MYER MARINE SUBDIVISION

APPLICATION NUMBER 10 DATE January 16, 2014

REQUEST Subdivision

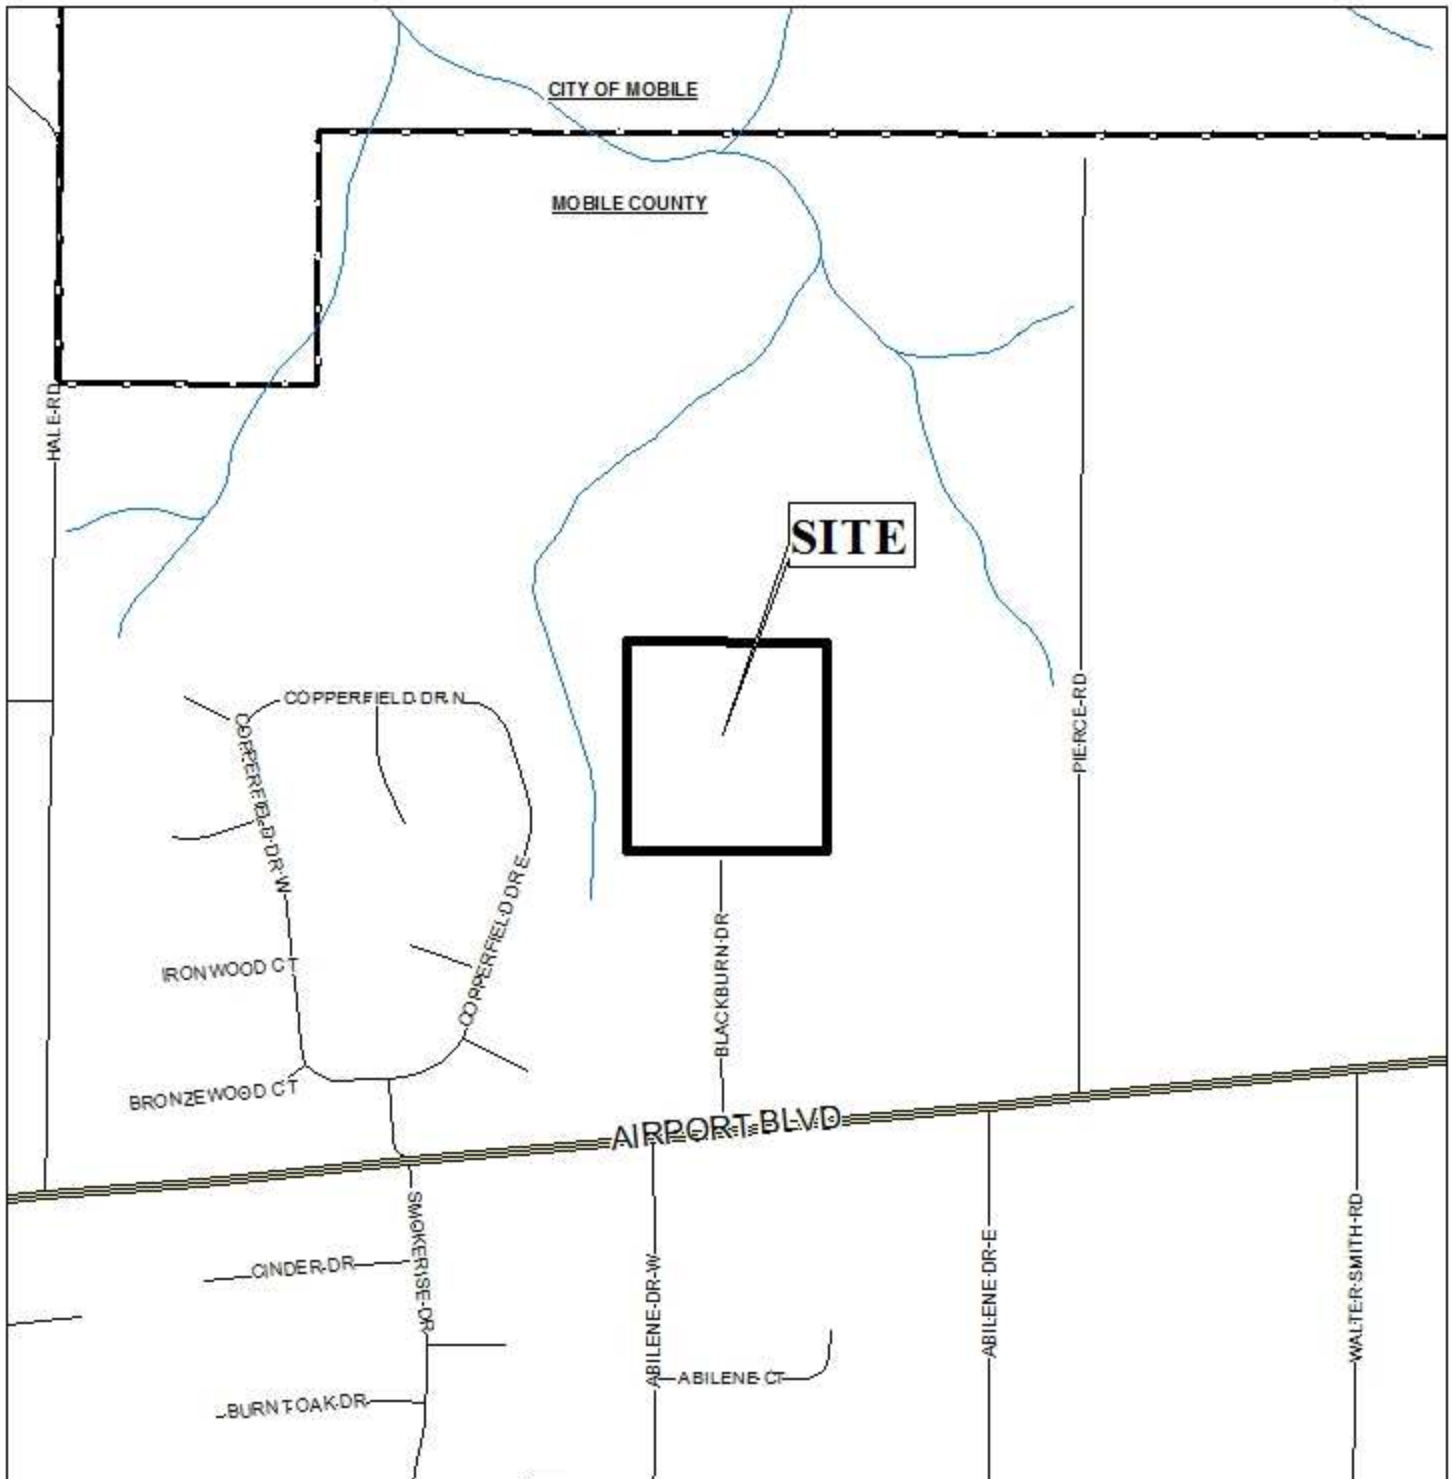
Blackburn Drive is a minor street, with an existing right-of-way of 50 feet. The street terminates at the proposed site, and a temporary turn-around is provided partially on the two adjacent lots from the previous phase. A condition of the 1985 approval was that *“any future development of this property would require the provision of a street to the east.”*

As proposed, the applicant does not intend to extend Blackburn Drive, nor provide a cul-de-sac, as required by Section V.B.14. of the Subdivision Regulations. As for providing a street to the east, the property to the east of the site is fully developed and has street frontage of its own, thus the provision of a street should no longer be required.

It should be noted that Blackburn Drive is approximately 690 feet in length from its intersection with Airport Boulevard. Section V.B.6. of the Subdivision Regulations states that *“ordinarily, closed-end streets (cul-de-sacs) shall not be longer than 600 feet, and shall be provided at the closed-end with a turnaround. Where the closed-end street is expected to be continued in the*

future into unsubdivided land, the turnaround may be a temporary one.” As the current proposal will create the final lot within the subdivision, it should provide a permanent cul-de-sac in compliance with the Subdivision Regulations, as originally proposed in 1985.

As the site will be the final lot within the subdivision, the number, size, design and location of any curb-cuts should be approved by Mobile County Engineering and comply with AASHTO standards.

The 25-foot minimum building setback is not shown on the plat. The plat should be revised to depict the minimum building setback line to be a minimum of 25-feet from any street right-of-way.

The lot size information on the preliminary plat is depicted in acres, but should be modified to also include square feet. The plat should be revised to include the lot size in square feet.

This site is located in the County, thus any lots which are developed commercially and adjoin residentially developed property must provide a buffer, in compliance with Section V.A.8. of the Subdivision Regulations. A note regarding this requirement should appear on the final plat.

The site will have to comply with the City of Mobile storm water and flood control ordinances. A note regarding this requirement should appear on the final plat.

The geographic area defined by the city of Mobile and its planning jurisdiction, including this site, may contain Federally-listed threatened or endangered species as well as protected non-game species. Development of the site must be undertaken in compliance with all local, state and Federal regulations regarding endangered, threatened or otherwise protected species. A note regarding the requirement should appear on the final plat.

Based on the preceding, the application is recommended for Holdover until the February 20th meeting, with revisions due by January 31st, so that the following revisions can be made:

- 1) Revision of the plat to provide a permanent cul-de-sac in compliance with Section V.B.14. of the Subdivision Regulations;
- 2) Revision of the plat to depict a 25-foot minimum building setback, as required by Section V.D.9. of the Subdivision Regulations;

- 3) Revision of the plat to include the lot size in square feet;
- 4) Placement of a note on the plat stating that *“the number, size, design and location of any curb-cuts are to be approved by Mobile County Engineering and comply with AASHTO standards;”*

- 5) Placement of a note on the plat stating that *“development of the site must be undertaken in compliance with all local, state and Federal regulations regarding endangered, threatened or otherwise protected species;”*

- 6) Placement of a note on the plat stating that *“any lots which are developed commercially and adjoin residentially developed property must provide a buffer, in compliance with Section V.A.8. of the Subdivision Regulations;”*

- 7) Placement of a note on the plat stating that *“the site must comply with the Mobile County Flood Damage Prevention Ordinance. Development shall be designed to comply with the*

storm water detention and drainage facility requirements of the City of Mobile storm water and flood control ordinances, and requiring submission of certification from a licensed engineer certifying that the design complies with the storm water detention and drainage facility requirements of the City of Mobile storm water and flood control ordinances prior to the issuance of any permits. New public roads shall be constructed and paved to standards for County Maintenance, and accepted by Mobile County, while new private roads shall be constructed and paved to minimum County or Subdivision Regulation standards, whichever are greater;” and

- 8) Compliance with Fire comments: “All projects within the City of Mobile Fire Jurisdiction must comply with the requirements of the 2009 International Fire Code, as adopted by the City of Mobile.”
